**Number:** SMB010022      **Date:** April 6,2001      **Supersedes:** N/A      **Date:**  
**Title:** 30 series ComfortLink Nuisance Alerts 051-057  
**Category:** *General*      **Termination Date:** None  
**Author:** Lewis Clark  
**Dept:** CSS Service Engineering

**Models**      CAC: 30GTN, GTR, GUN, GUR, HK, HL, HW with ComfortLink Controls  
**Affected:**      BDP: None

# CONTROL RELAY MODIFICATION

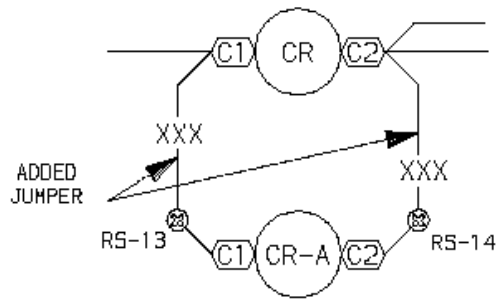
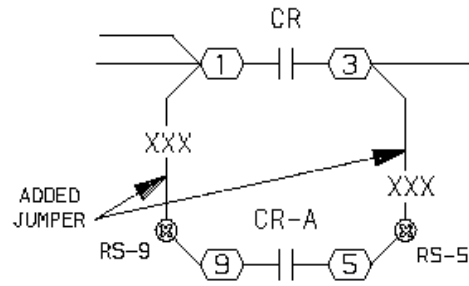
There have been many complaints regarding nuisance A051 alarms and T051-057 alerts on chillers with ComfortLink controls. The alarms continue even after all the safeties have been ruled out. The only component left is the control relay.

We have determined the root cause of the problem to be the contacts used in the HN61KK025 control relay which provide the 5 vdc feedback signal to the main base board (MBB). The current through this circuit is approximately 2 mA. Under certain operating conditions the contacts do not make properly and the MBB interprets this as a failure.

1. Replace the HN61KK025 control relay. Relays identified with a date code of 0114 or later have the contact pressure increased.
2. Install RCD kit 30GT660005, which consists of a HN61KZ024 control relay and HY07RB030 base. This relay has bifurcated contacts rated for the low current. The coil is wired in parallel with the existing control relay. The N.O. contacts are wired in parallel with terminals 1 and 3 of the existing relay. This is not a direct replacement. Installation instructions are attached.
3. On 30GTN,GUN040-070 install the accessory Compressor Ground Current Protection Module (30GB900131).
